CITY OF ALBUQUERQUE

**Re: Rabadi Square Condo Complex Grading and Drainage Plan
Engineer's Stamp dated 11-22-05 (B12/D2)**

Re: Revised Grading & Drainage for Rabadi Square, ZAP A-12
Engineer's Stamp Dated November 22, 2005

GRADING AND DRAINAGE PLAN
RABADI SQUARE

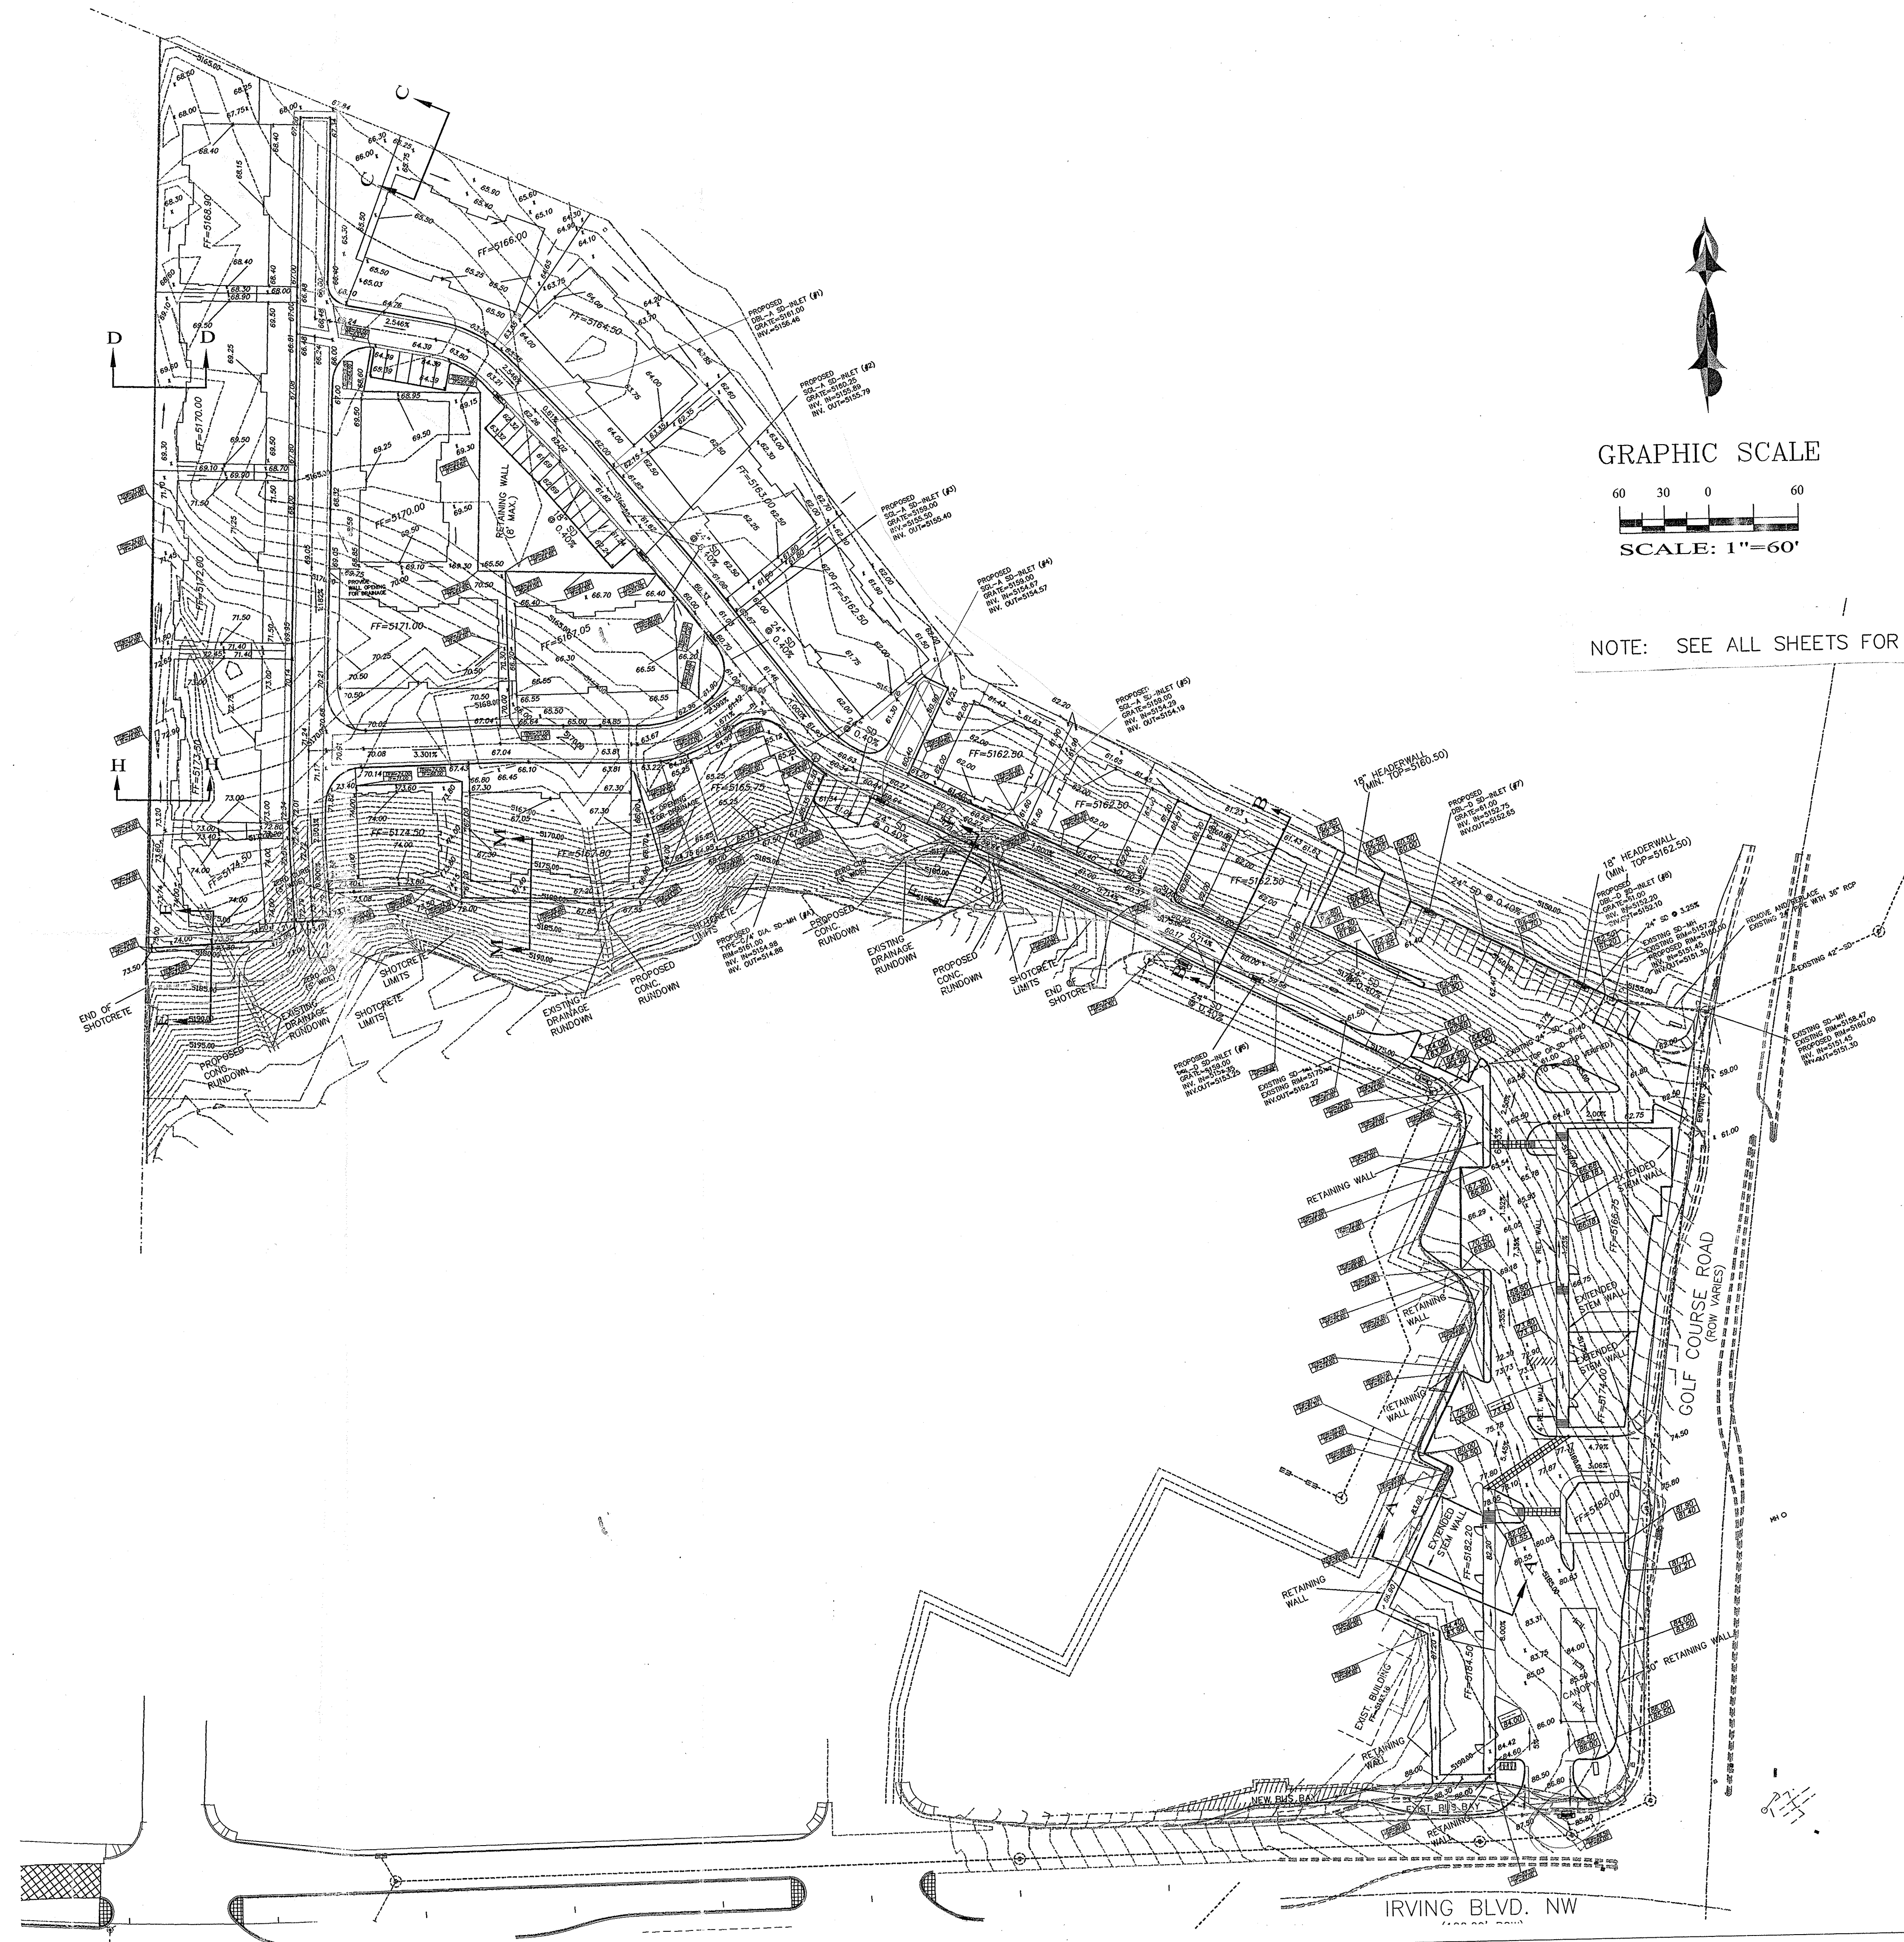
- Need design of
slope protection to
compare with adjoining grades
